Product/Process  
Change  
Notification  
**PCN08156**

<b>Product:</b>	Power Edge Card Connector		<b>Part Numbers Concerned:</b>	All Power Edge Card series. See attached list
<b>Product Manager:</b>	Sally Luo		<b>Issue Date:</b>	8th Nov 2008
			<b>Page(s):</b>	1/2
<b>Distribution:</b>	Active and Contract Customers

Change ink printing to Laser marking for Power Edge Card date code

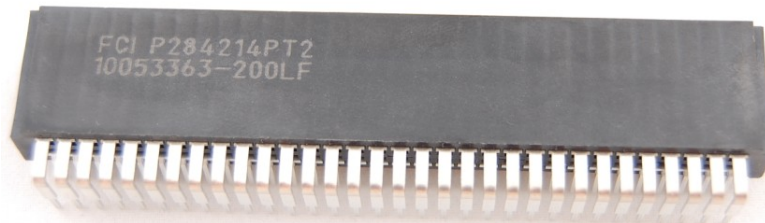
Laser marking is an excellent way to permanently mark on product, in order to avoid any risk of the ink printing date code being blurred or dissolved by cleaning impregnant during customer's assembly process. FCI plan to change ink printing to Laser marking date code. The date code content would be no change.

Jan.01, 2009, will phase in if no rejection for this change from customer.
